SUBJECT: PALO VERDE NUCLEAR GENERATING STATION, UNITS 1, 2, AND 3 -  
ISSUANCE OF AMENDMENTS ON FUEL STORAGE POOL CAPACITY (TAC  
NOS. MA5685, MA5686 AND MA5687)

The Commission has issued the enclosed Amendment No. 125 to Facility Operating License No. NPF-41, Amendment No. 125 to Facility Operating License No. NPF-51, and Amendment No. 125 to Facility Operating License No. NPF-74 for the Palo Verde Nuclear Generating Station, Units 1, 2, and 3, respectively.

ATTACHMENT TO LICENSE AMENDMENT NOS. 125, 125, AND 125  
FACILITY OPERATING LICENSE NOS. NPF-41, NPF-51, AND NPF-74  
DOCKET NOS. STN 50-528, STN 50-529, AND STN 50-530

SAFETY EVALUATION BY THE OFFICE OF NUCLEAR REACTOR REGULATION  
RELATED TO AMENDMENT NO. 125 TO FACILITY OPERATING LICENSE NO. NPF-41,  
AMENDMENT NO. 125 TO FACILITY OPERATING LICENSE NO. NPF-51,  
AND AMENDMENT NO. 125 TO FACILITY OPERATING LICENSE NO. NPF-74  
ARIZONA PUBLIC SERVICE COMPANY, ET AL.  
PALO VERDE NUCLEAR GENERATING STATION, UNITS 1, 2, AND 3  
DOCKET NOS. STN 50-528, STN 50-529, AND STN 50-530

Figure 3.7.17-1  
ASSEMBLY BURNUP VERSUS INITIAL ENRICHMENT  
for  
Region 2

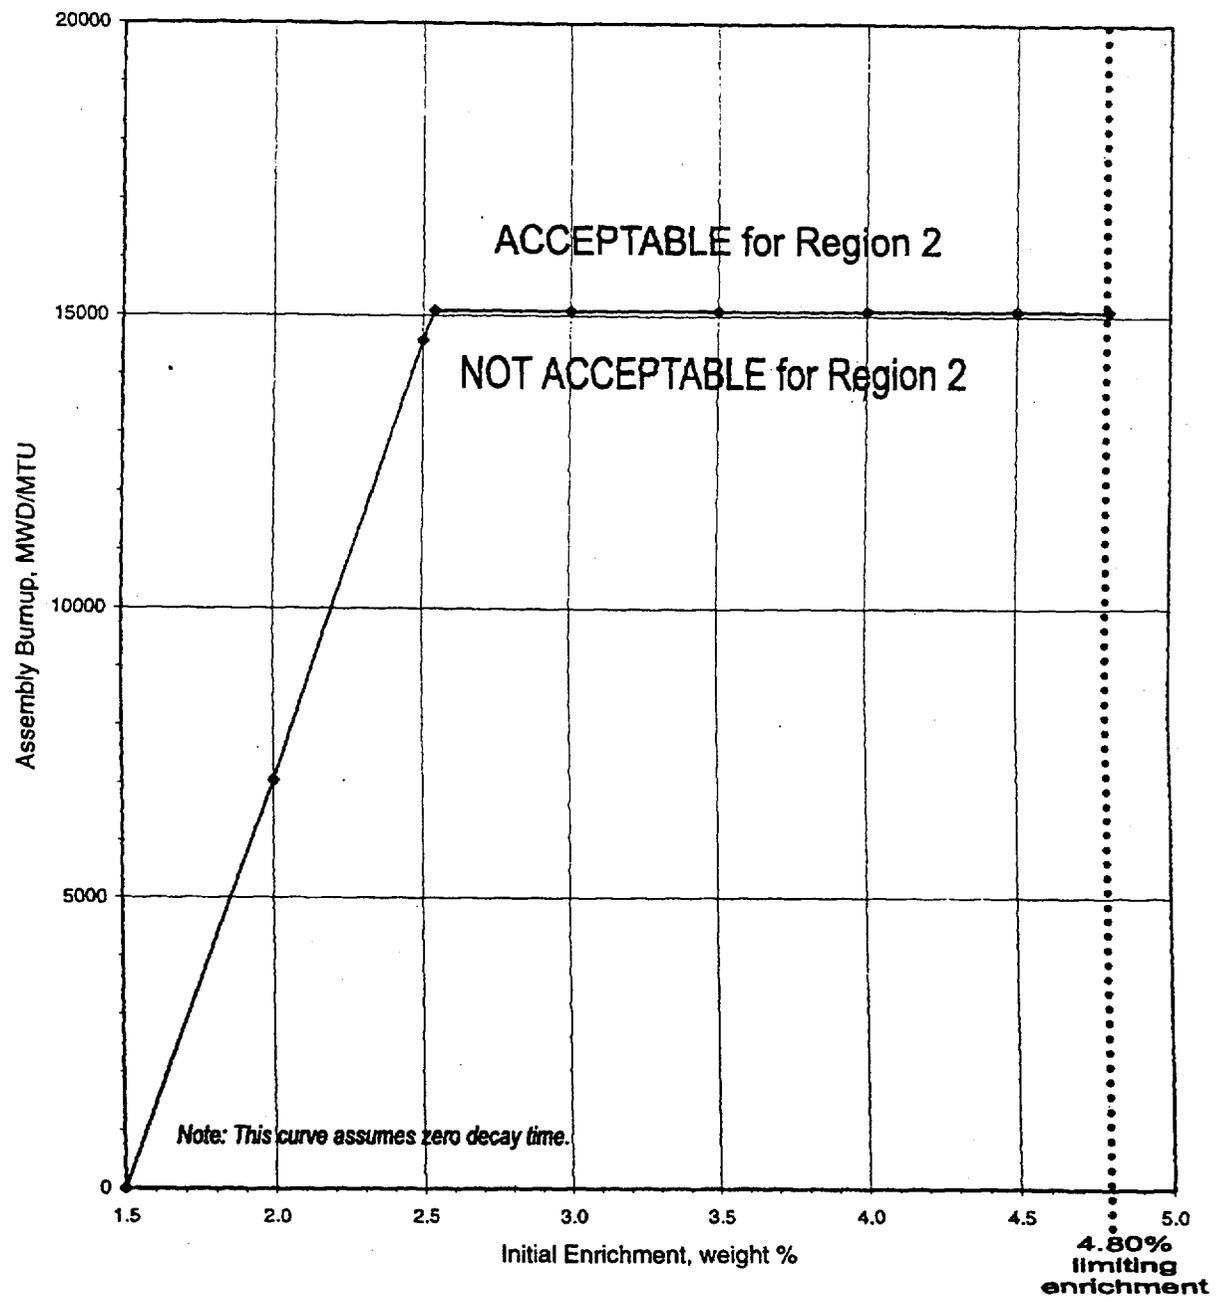
LCO 3.7.17 The combination of initial enrichment, burnup, and decay time of each fuel assembly stored in each of the four regions of the fuel storage pool shall be within the acceptable burnup domain for each region as shown in Figures 3.7.17-1, 3.7.17-2, or 3.7.17-3, and described in Specification 4.3.1.1.

The licensee proposes to modify TS 3.7.15, "Fuel Storage Pool Boron Concentration," to make it applicable whenever any fuel assembly is stored in the fuel storage pool. TS 3.7.17, "Spent Fuel Assembly Storage," would be revised to include decay time along with modified initial enrichment and burnup requirements to determine the region in which each fuel assembly can be stored. In addition, the maximum radially averaged enrichment allowed in the figures would be increased from 4.3 to 4.8 w/o U-235. TS 4.3.1, "Criticality," would be revised to require a  $k_{\text{eff}}$  less than 1.0 (including all biases and uncertainties) with the spent fuel pool fully flooded with unborated water and a  $k_{\text{eff}} \leq 0.95$  (including all biases and uncertainties) with the spent fuel pool flooded with water borated to 900 ppm. These proposed TS changes are consistent with the revised criticality analysis evaluated above. Based on this consistency and on the use of approved methodology, the staff finds these TS changes acceptable.

Figure 3.7.17-3  
ASSEMBLY BURNUP VERSUS INITIAL ENRICHMENT  
for  
Region 4  
(at decay times from 0 to 20 years)

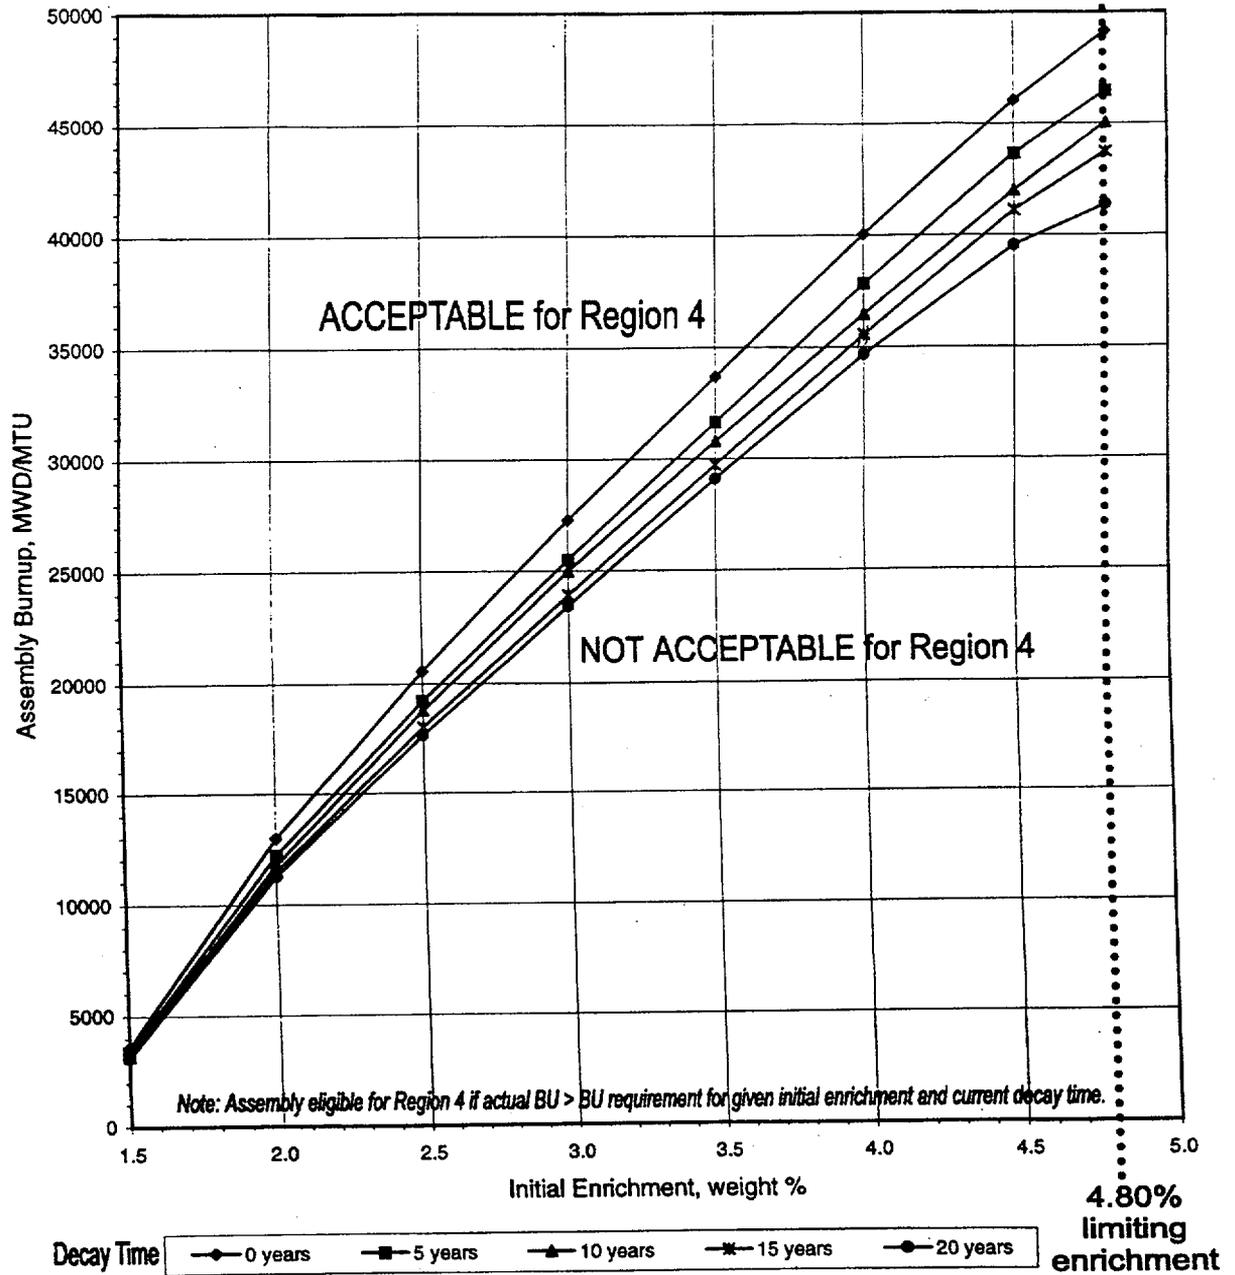
- h. Region 4: Fuel shall be stored in a repeating 3-by-4 storage pattern in which Region 2 (two-out-of-twelve) assemblies and Region 4 (ten-out-of-twelve) assemblies are mixed as shown in Section 9.1 of the UFSAR. Only fuel that qualifies to be stored in Region 4 in accordance with Figure 3.7.17-3 shall be stored in Region 4.
